**CITY OF KIRKLAND**  
**Planning and Building Department**  
123 Fifth Avenue, Kirkland, WA 98033  
425.587.3600 ~ [www.kirklandwa.gov](http://www.kirklandwa.gov)

**To:** Design Review Board  
**From:** Aoife Blake, Associate Planner  
**Date:** September 6, 2022  
**File No.:** DRV22-00466  
**Subject:** **SWYFT APARTMENTS  
DESIGN RESPONSE CONFERENCE**

# SWYFT APARTMENTS

DESIGN RESPONSE CONFERENCE

## DRC // STREETSCAPE MATERIALS - 128TH FRONTAGE

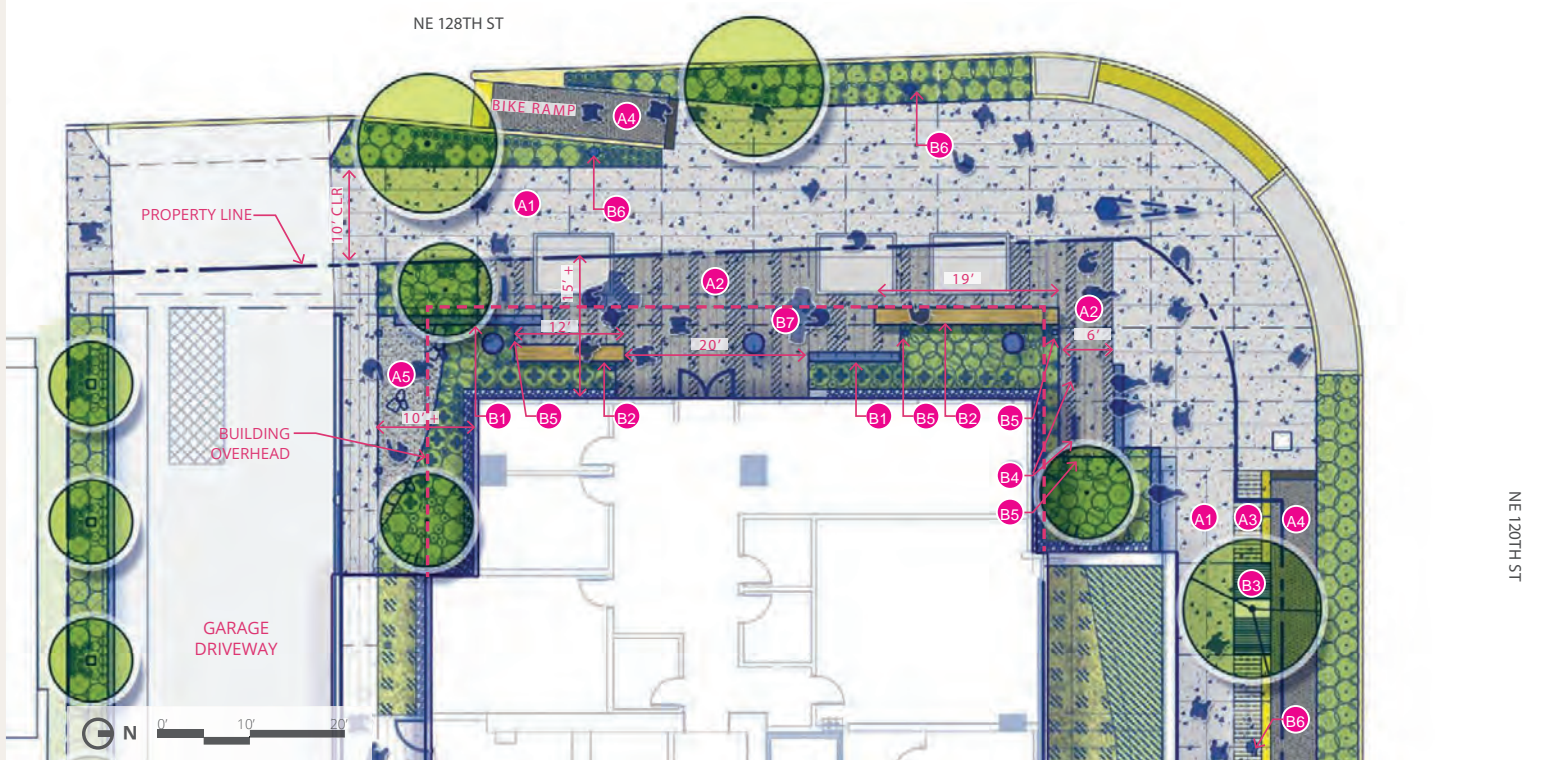
- NE 128<sup>th</sup> Street Entry Plaza: *The DRB requested the applicant look at ways to activate the space with street furniture or other opportunities. The applicant has revised the space (see page 4 of Attachment 2) to illustrate different paving materials, further seating arrangements, and lighting. This space meets the required size and dimensions for the public plaza required by KZC 55.09.040, special regulation 3.a.1.b*
- South-East Corner of Building: *The DRB requested the applicant look at refining the entrance at the south-east corner of the building*

*Paving: The applicant is proposing several different finishes to the concrete paving for the project such as light and heavy sandblasting, light and heavy broom finishes (see pages 3-6, Attachment 2).*

## DRC // SW CORNER CONNECTION

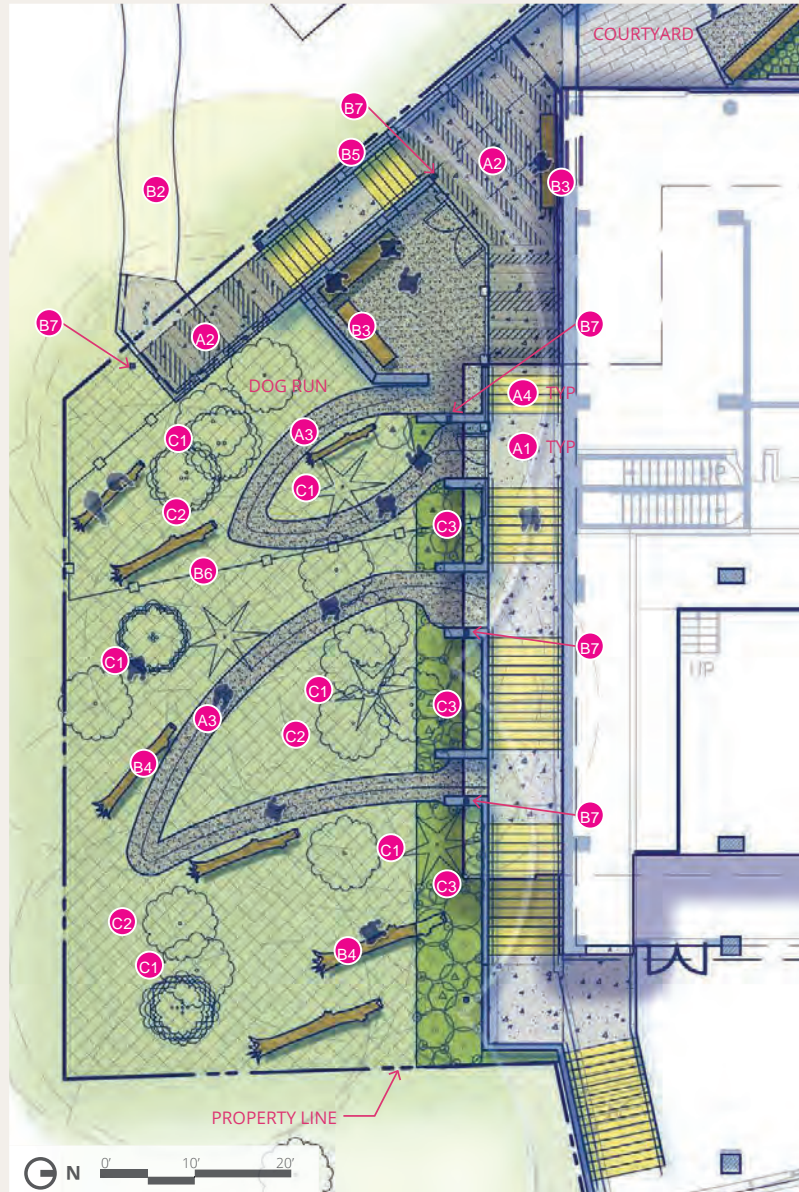
- *Through block connection (south-west of site): The DRB requested the applicant look at providing an end point for this through block connection. The purpose of this through block connection is to connect pedestrians from NE 128<sup>th</sup> Street to the Village at Totem Lake property. It is intended to link up with a pedestrian connection on the Village at Totem Lake property. Staff will notify the Village at Totem Lake of this connection requirement.*

# DRC // SITE LIGHTING

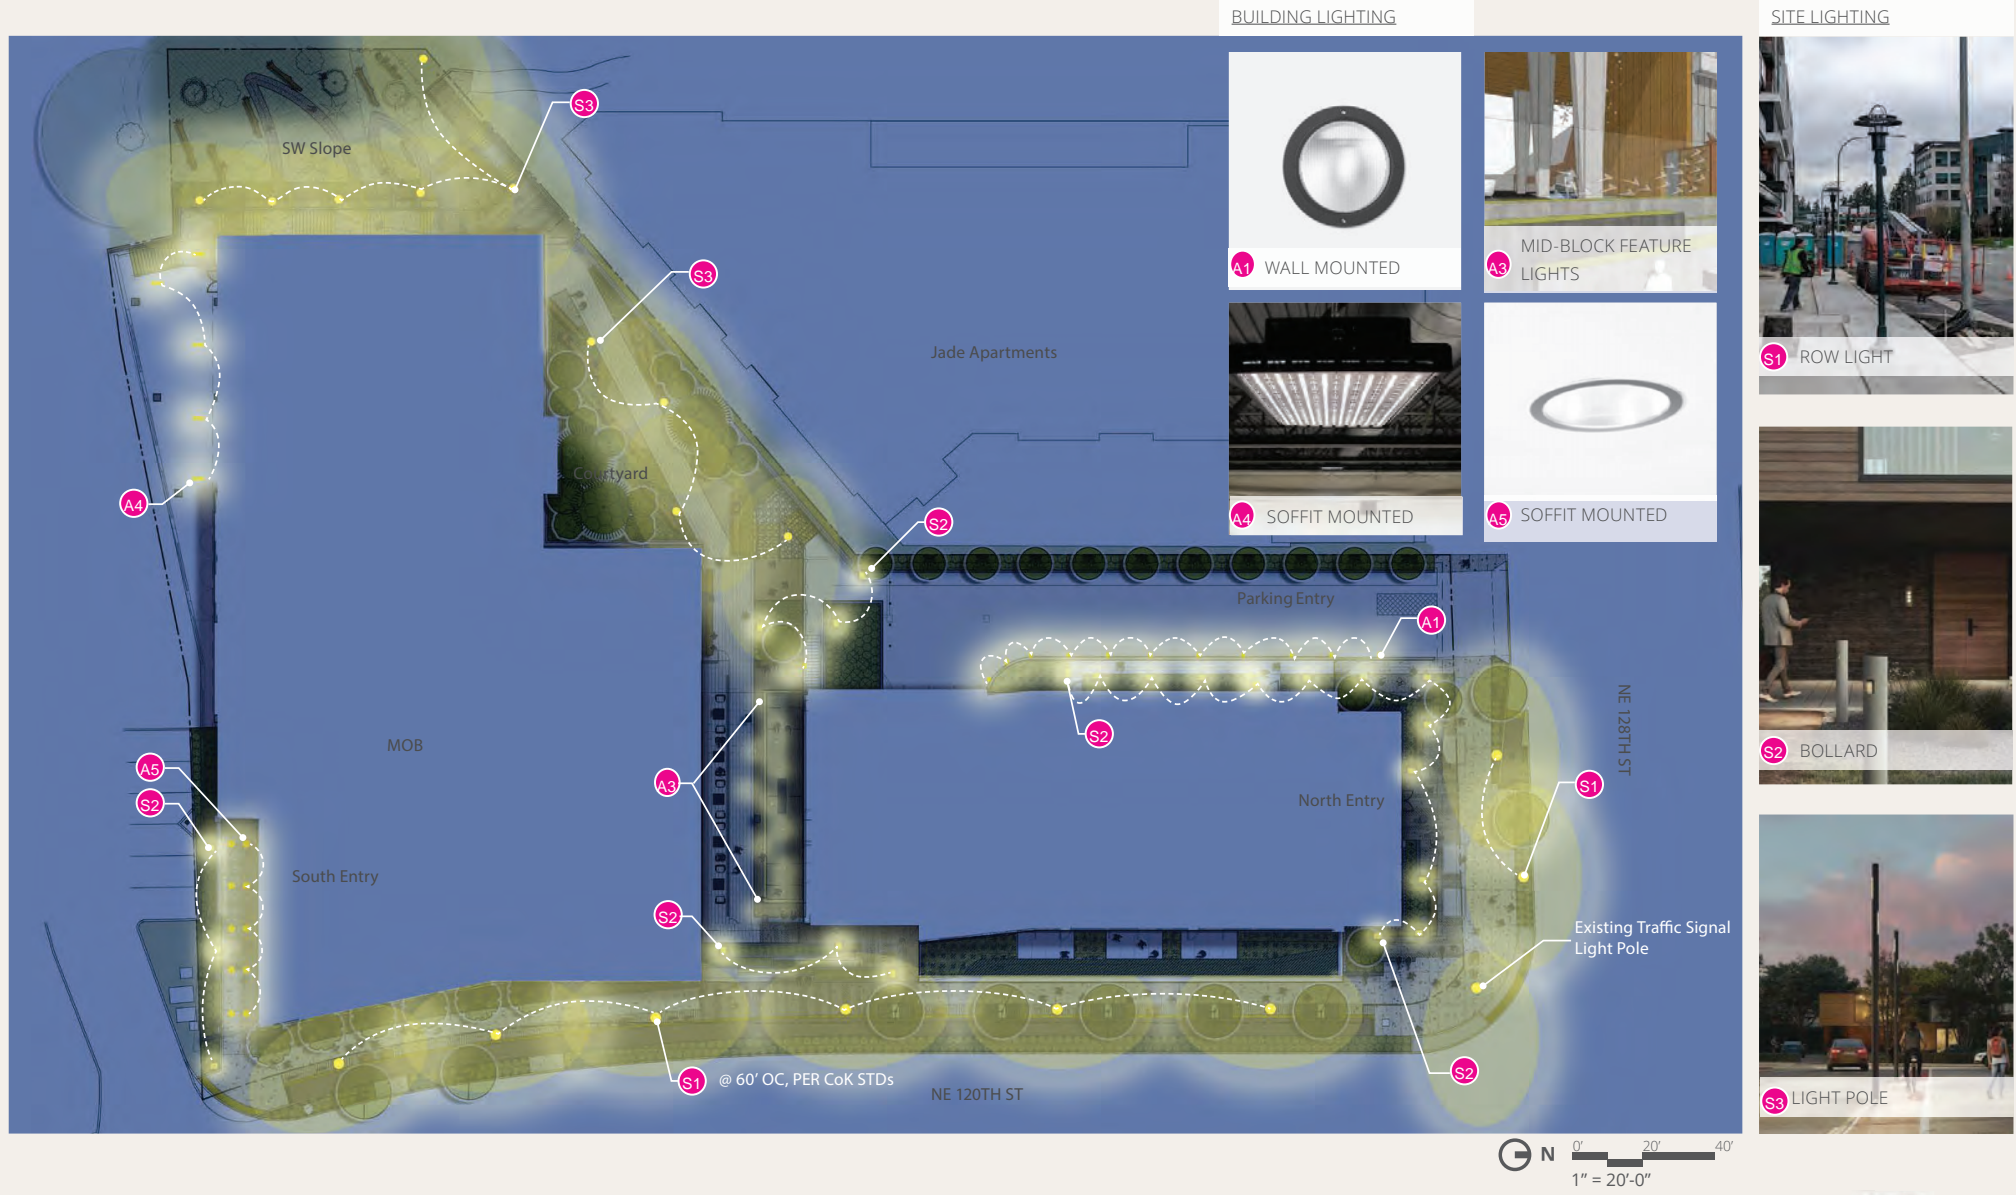
*Lighting: The applicant has provided a detailed lighting plan (see page 7, attachment 2) that illustrates the type and location of lighting for the project on private property and in the right-of-way. Main entry points to the building and pedestrian areas appear well-lit.*

## DRC // SE BUILDING ENTRY

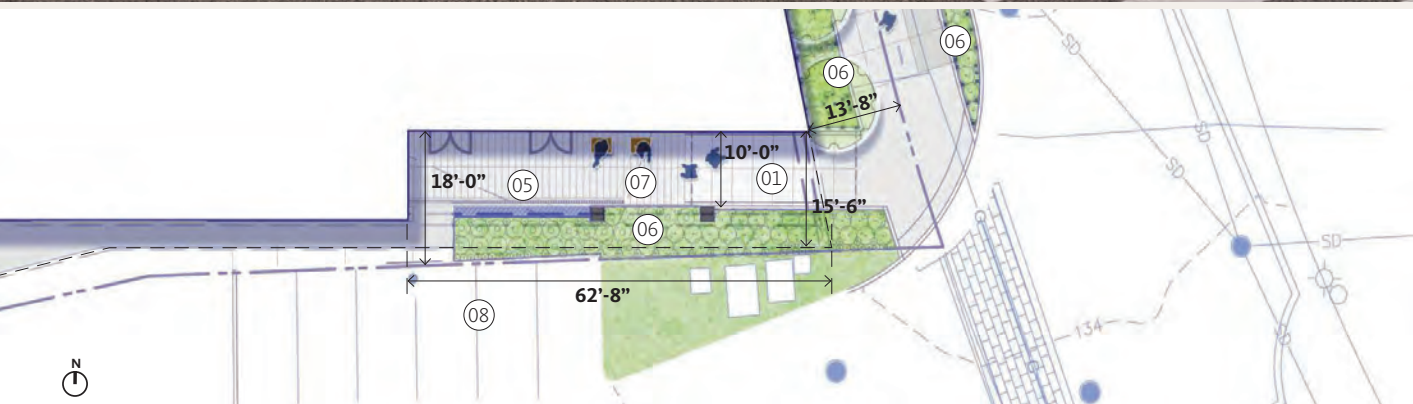
*to make it more inviting and align with the scale of the rest of the building. The applicant has addressed these comments by changing landscape species to create an unobstructed visual connection to the interior, added an accent material (phenolic wood panel) and lighting to highlight the entry. The applicant has provided a side-by-side comparison of these changes (see page 8 & 9, Attachment 2).*

- ① Facade set back to provide 15' deep pedestrian accessible area along building entry, creating larger public entry plaza
- ② Direct pedestrian access with overhead weather protection and integrated lighting for visibility and security
- ③ Structural columns exposed to provide scale and detail
- ④ Clear glass providing visual connection to interior
- ⑤ Pedestrian bench seating under cover as an amenity along major access
- ⑥ Landscaping to soften edges
- ⑦ Concrete paving with distinctive scoring and scale change on property to highlight entry
- ⑧ Convenience parking near entry
- ⑨ Frontage improvements as per the required Totem Lake roadway enhancements
- ⑩ Upper level material change to accentuate and highlight entry

## DRC // 120TH AVE FACADE AND MID BLOCK CONNECTION

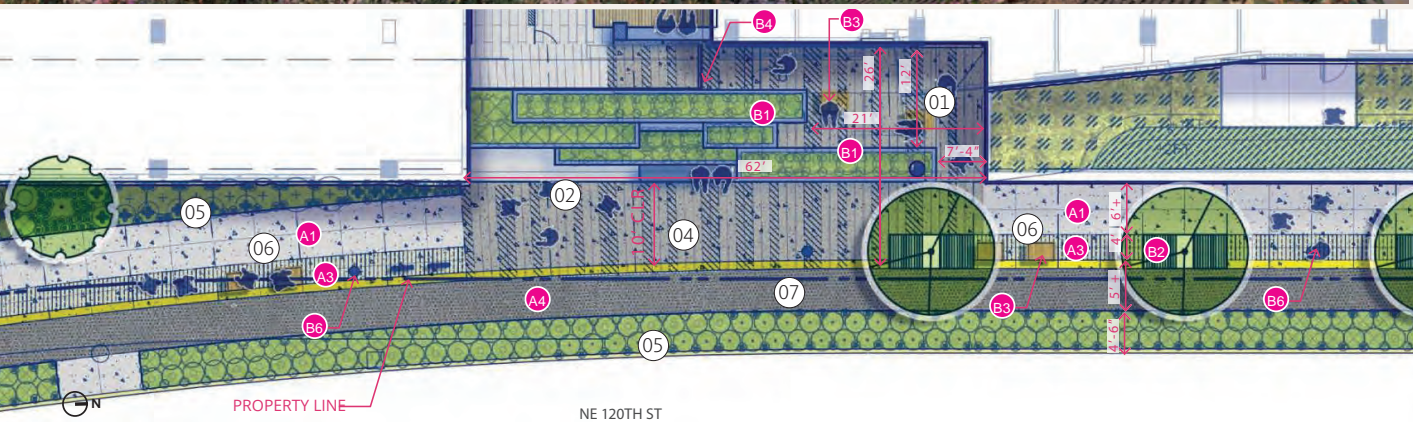
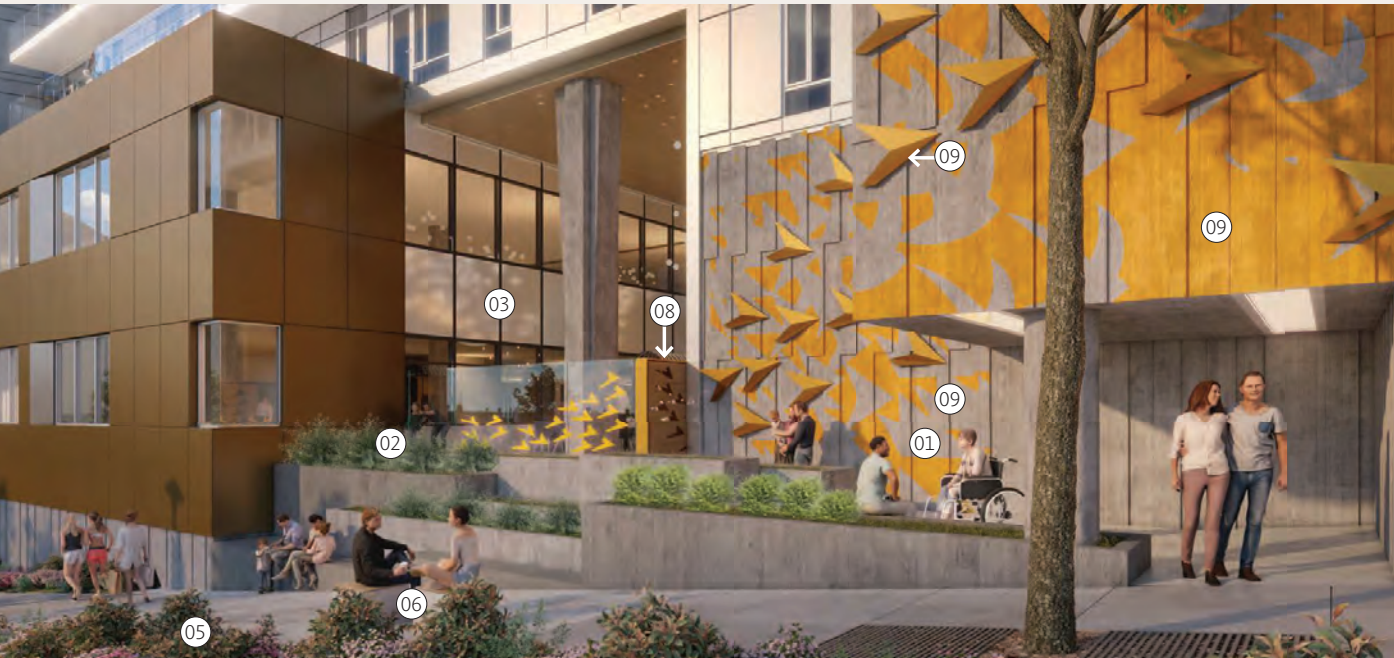
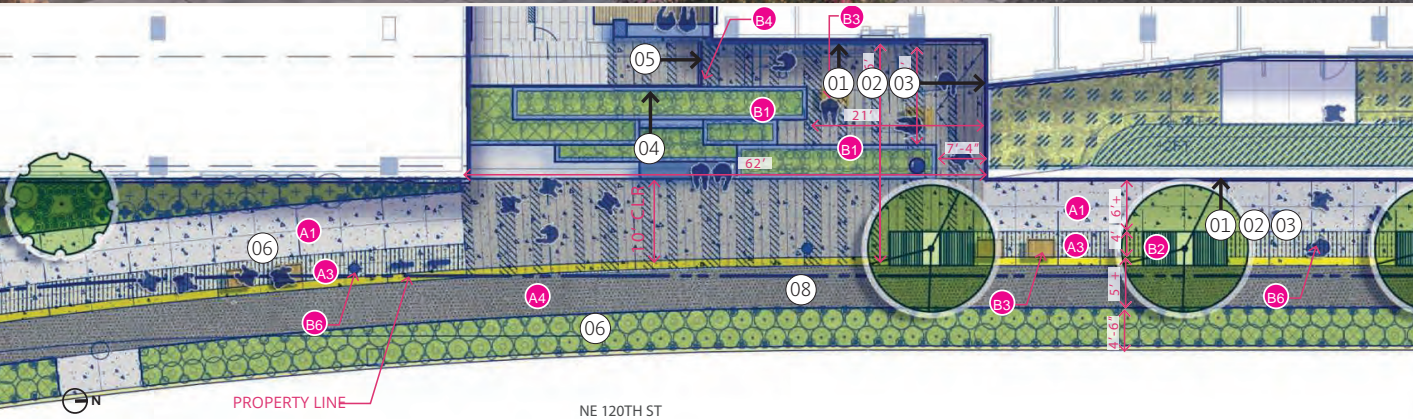
##### c. **Staff Analysis:** *The applicant has provided updated plans that revise the approach to the blank wall along 120<sup>th</sup> Avenue NE (see pages 10-13, Attachment 2). Staff has reviewed the plans and has the following comments:*

- *At the August 4<sup>th</sup> meeting, the applicant proposed the garage wall along 120<sup>th</sup> Avenue NE be treated with board-form concrete, smooth stained concrete at regular intervals, steel cables to support vine growth, landscaping on podium top, lighting, and sculptural art accents.*
- *The applicant has revised the blank wall treatment to maintain the board form concrete and added a painted mural with some metal sculptures. The mural emerges from the mid-block connection northward along 120<sup>th</sup> Avenue NE and fades out towards NE 128<sup>th</sup> Street intersection.*

- *Does the mural on the garage wall adequately treat the blank wall?*
- *Have the concerns around the blank wall along the 120<sup>th</sup> Avenue NE façade been addressed?*

- 01 Frontage carved away to provide small plaza as a flat, pedestrian friendly, respite, positioned mid way along hill climb as an area to pause and stop.
- 02 Articulated and terraced planters provide detail and reduce scale through a mixture of seating opportunities flanked by planters
- 03 Visual connection to commercial tenant space beyond engages pedestrians with building interior
- 04 Frontage improvements as per the required Totem Lake roadway enhancements
- 05 Continuous perimeter landscaped edge
- 06 Intermittent seating as street furniture
- 07 Integrated bike lane
- 08 Gate that includes the bird pattern cut out
- 09 Continuous painted mural with three dimensional graphic representation of the swift bird.

- (01) Board-formed concrete wall providing material interest, texture and pop of color.
- (02) Continuous painted mural with graphic representation of the swift bird. Mural dissipates towards the upper north end.
- (03) Three dimensional graphic, sculptural metal birds attached to concrete wall an woven into mural. Birds fade out towards the upper northern end.
- (04) Graphic bird decal applied to glass guardrail
- (05) Gate that includes the bird pattern cut out
- (06) Continuous perimeter landscaped edge with Intermittent seating as street furniture
- (07) Murmuration light fixture in pass through
- (08) Dedicated bike lane
